Executive Director's Recommendation

PROJECT Rock Creek Park Trail Access and Safety Improvements Washington, DC	NCPC FILE NUMBER 7998
SUBMITTED BY United States Department of the Interior National Park Service	NCPC MAP FILE NUMBER 23.00(38.00)44894
REVIEW AUTHORITY Federal Projects in the District per 40 U.S.C. § 8722(b)(1) and (d)	APPLICANT'S REQUEST Approval of preliminary and final site development plans
	PROPOSED ACTION Approve preliminary and final site development plans with comments
	ACTION ITEM TYPE Open Session

Rock Creek Park Trail Access and Safety Improvements

Approval of Preliminary and Final Site Development Plans

Tree Removal/Replacement

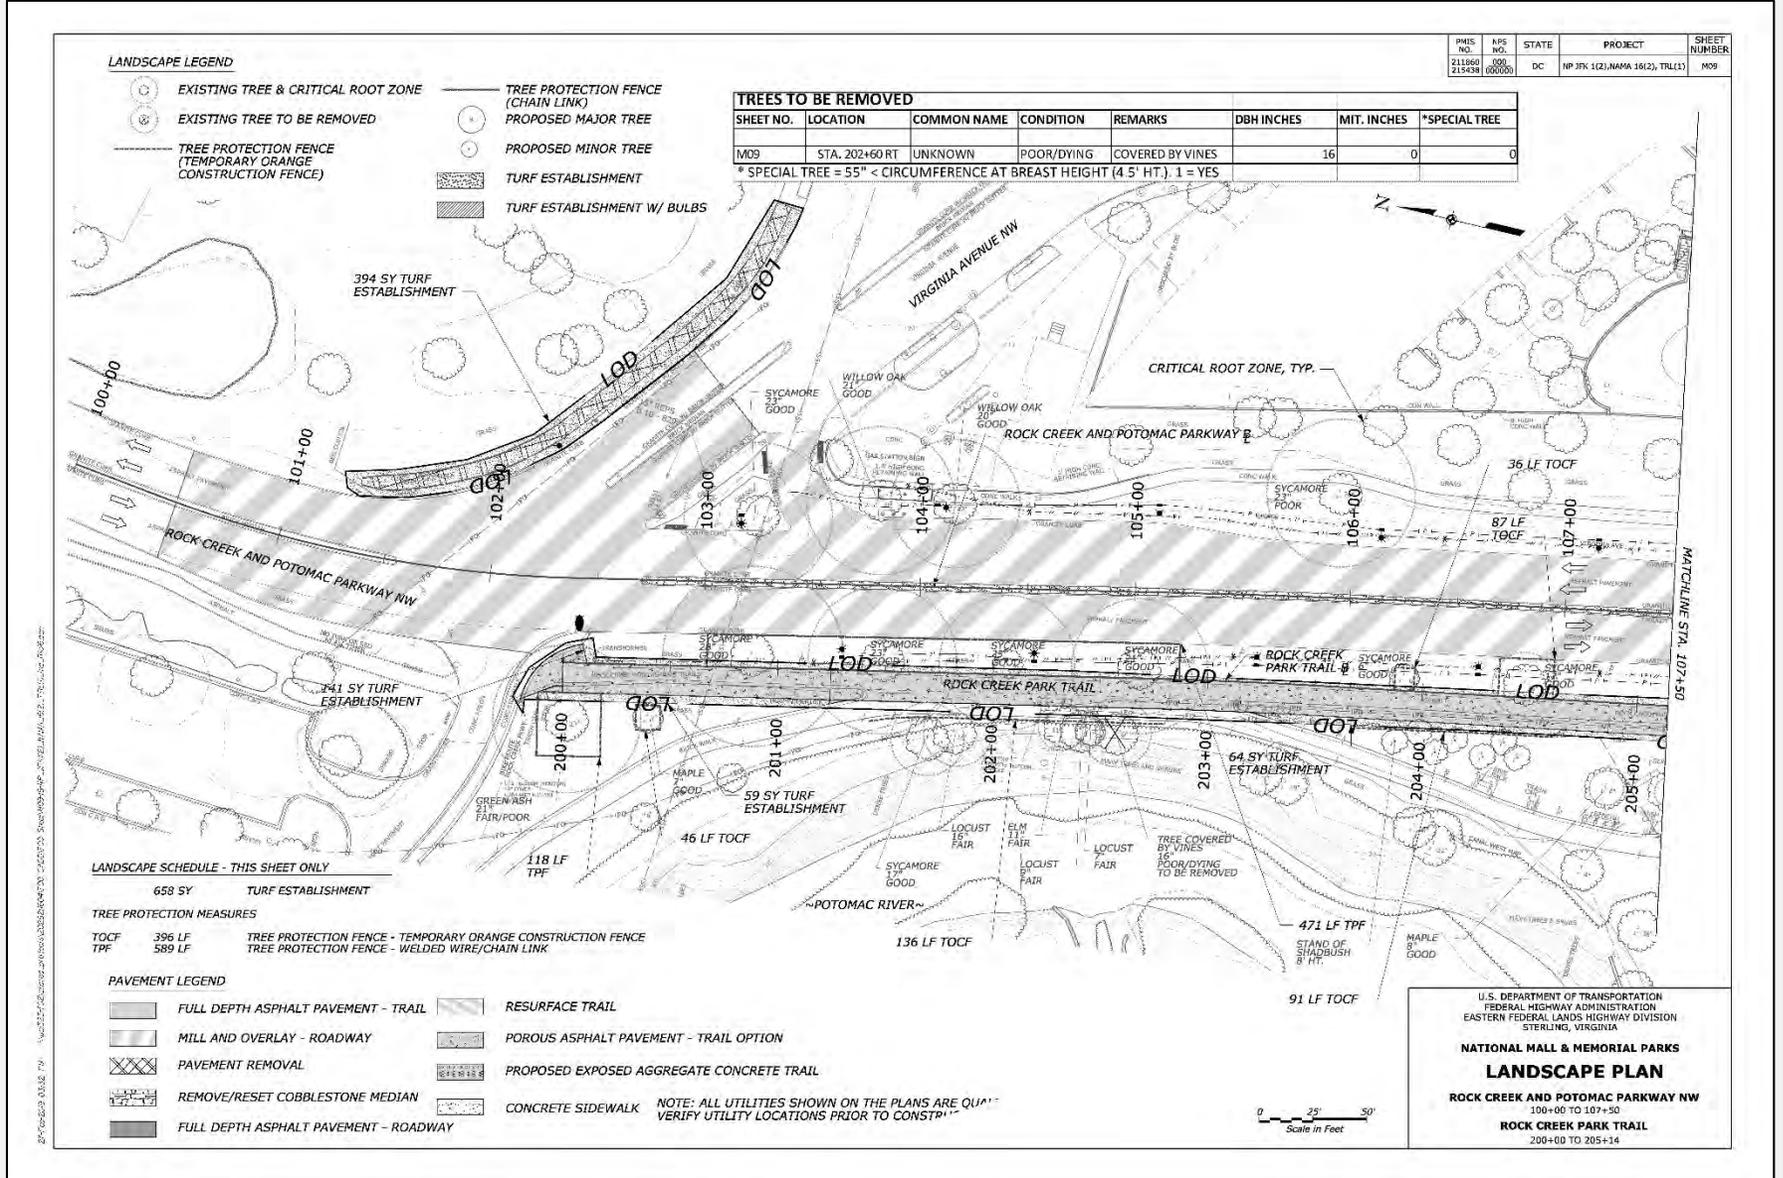
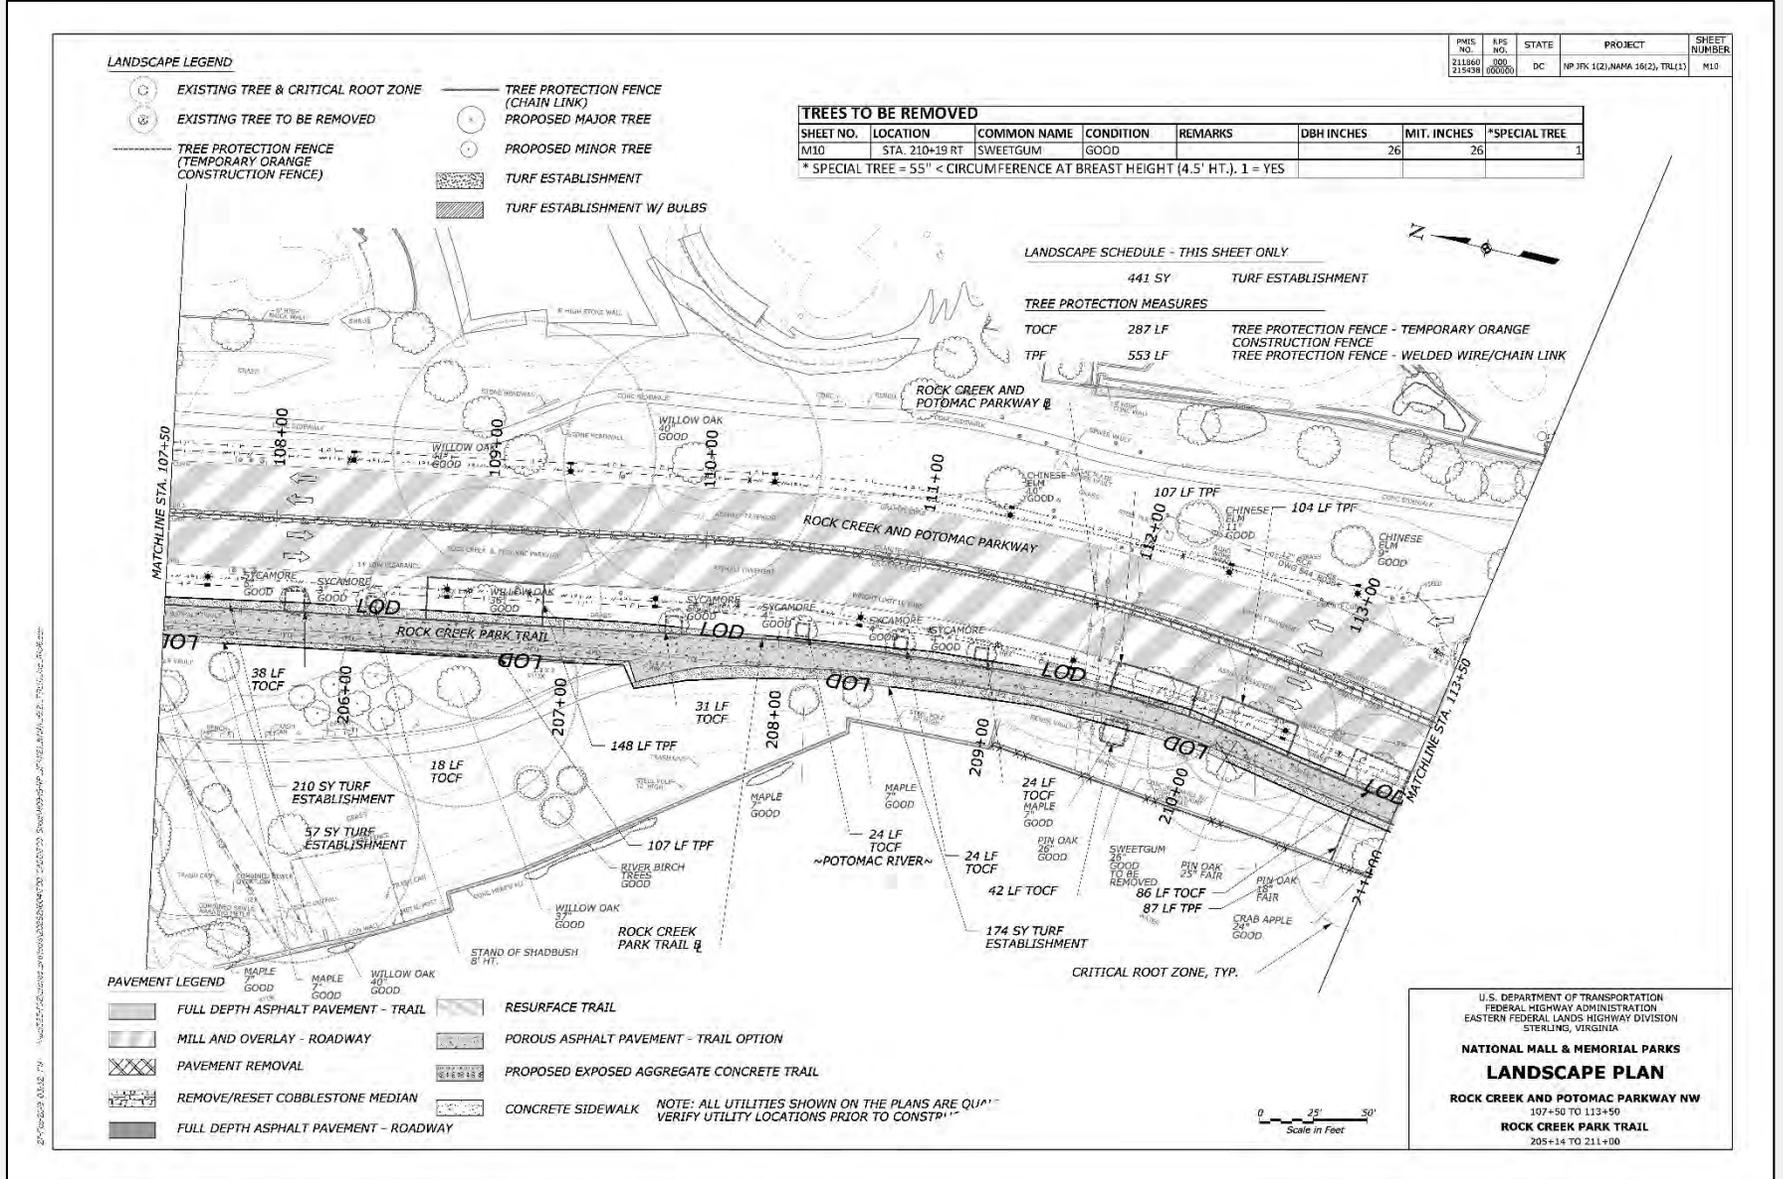
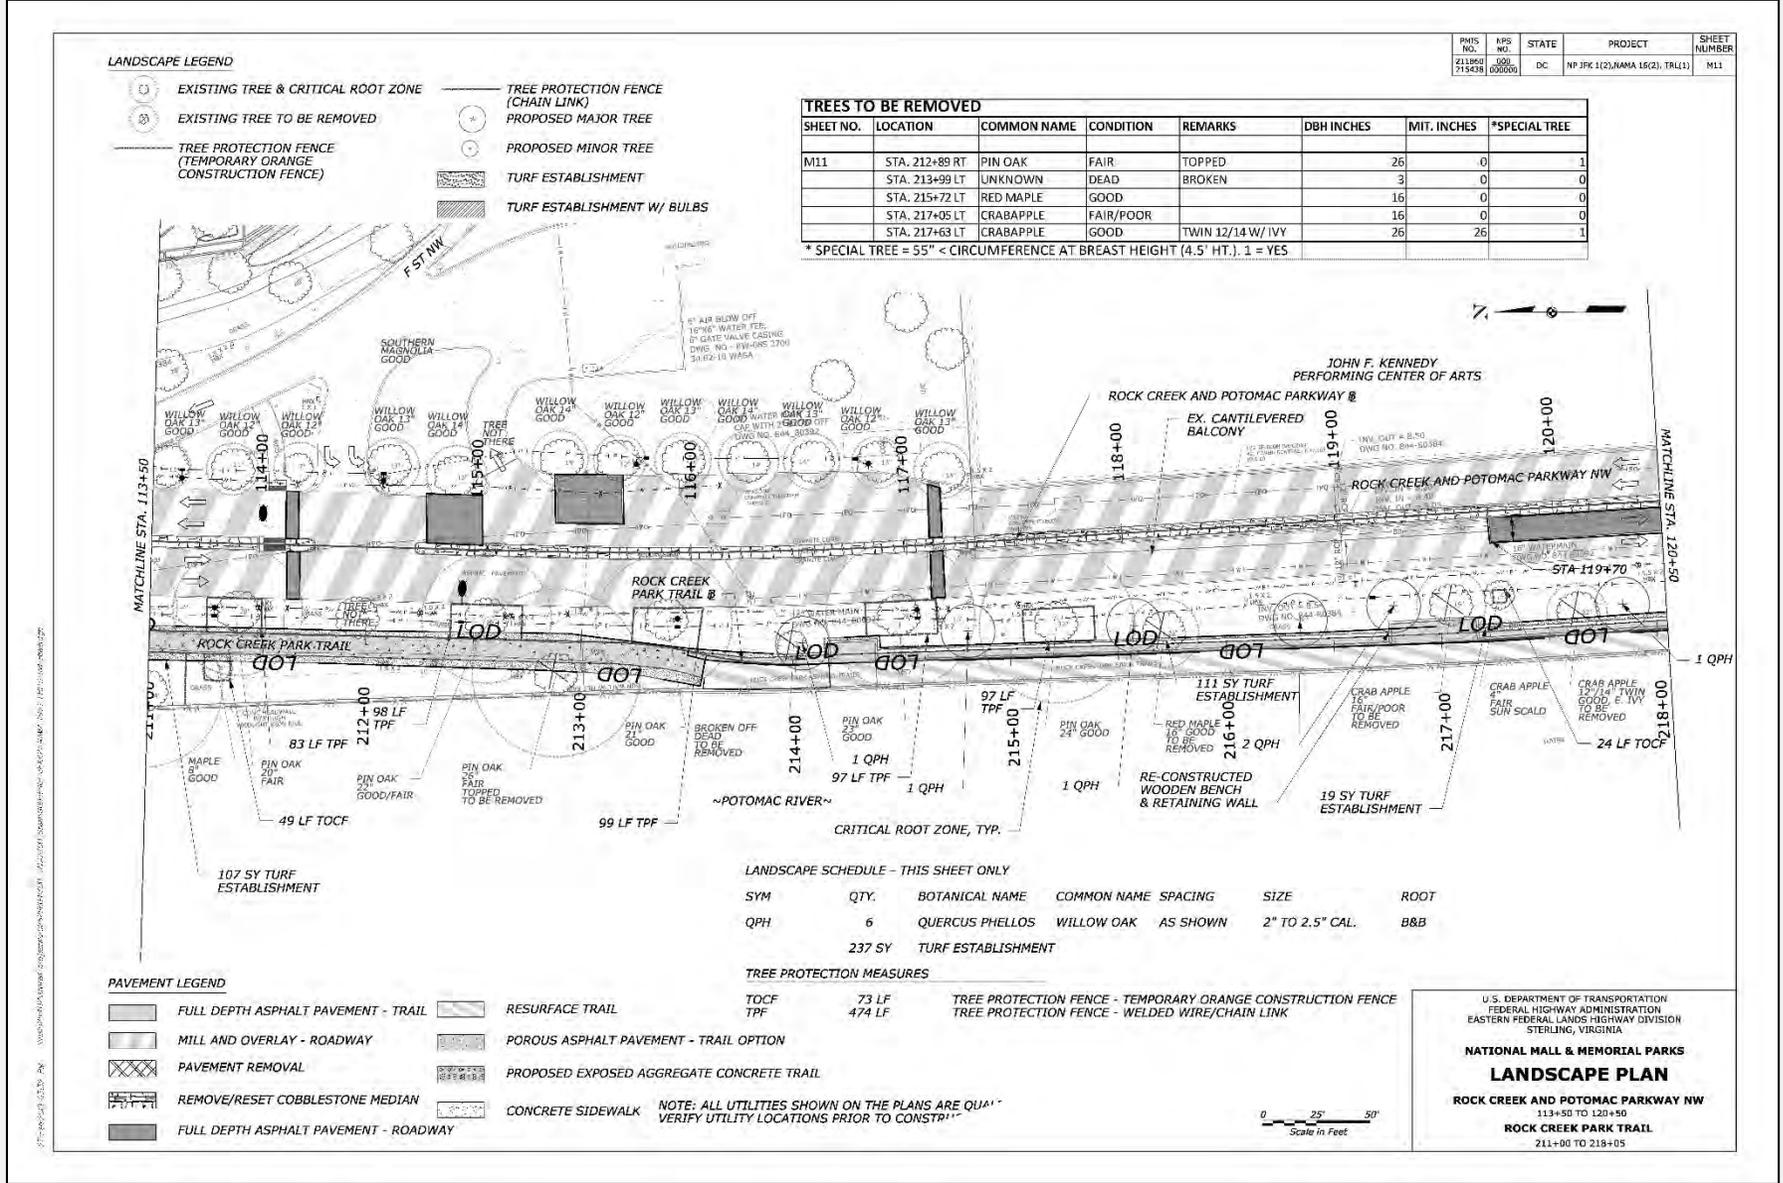
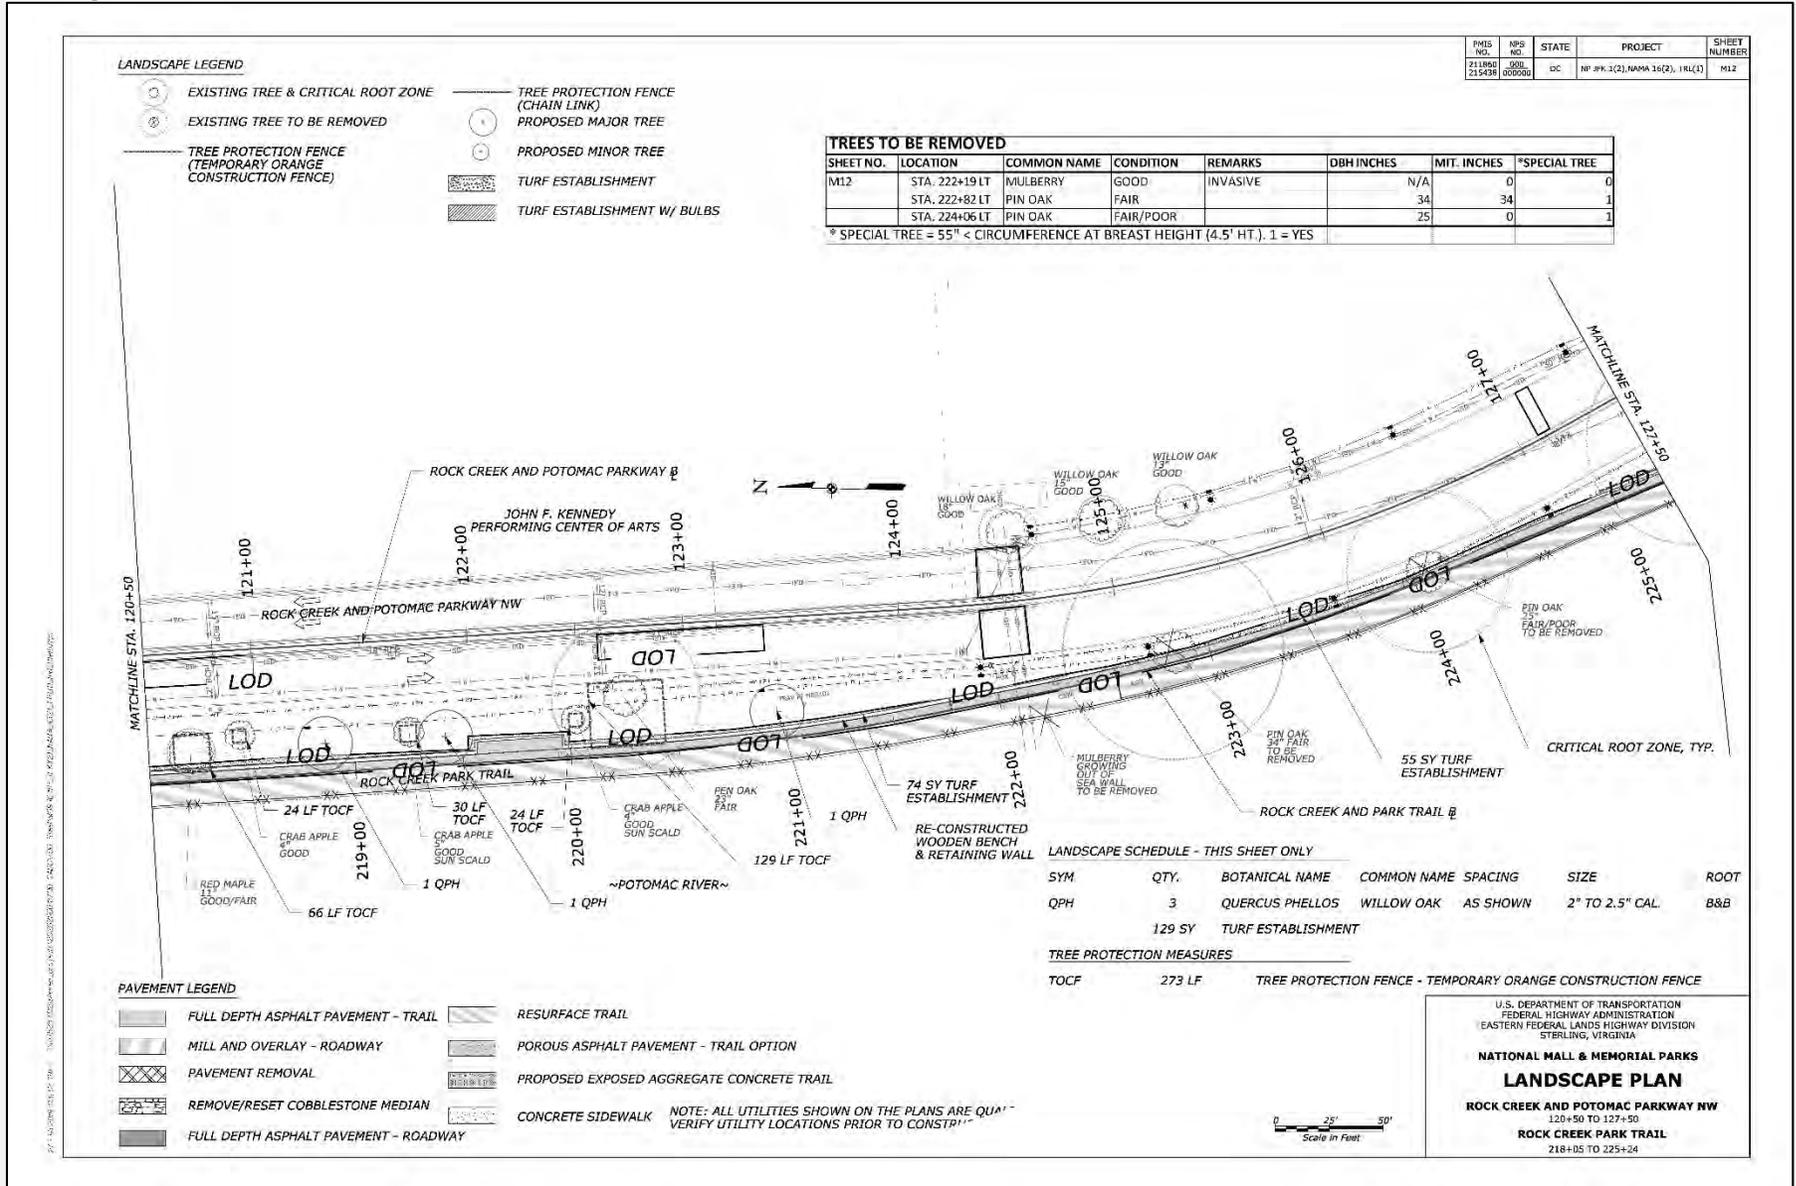
Notes that 13 trees will be removed as a result of the project, all of which are either in poor condition or directly impacted by the project construction. Guidance in the cultural landscape report for the site limit the number of trees that can be planted, so the project will still result in a

net loss of tree canopy, though all trees will be replaced with two-inch to two-and-a-half-inch caliper trees at a one-to-one ratio.

In response to Commission comments on the concept design, the applicant has provided more information on tree removal and replacement that would occur as a result of the trail widening. The applicant has indicated that 13 trees will be removed as a result of the project, all of which are either in poor condition or directly impacted by the project construction, and that all trees would be replaced with 2- to 2.5-caliper trees at a one-to-one ratio in accordance with the cultural landscape report for the site. Because many of the trees are larger and more mature, the replacement trees will not fully mitigate the loss of tree canopy. Despite the net loss of tree canopy, staff believes that the tree replacement strategy effectively balances preservation of the historic landscape with natural resource considerations.
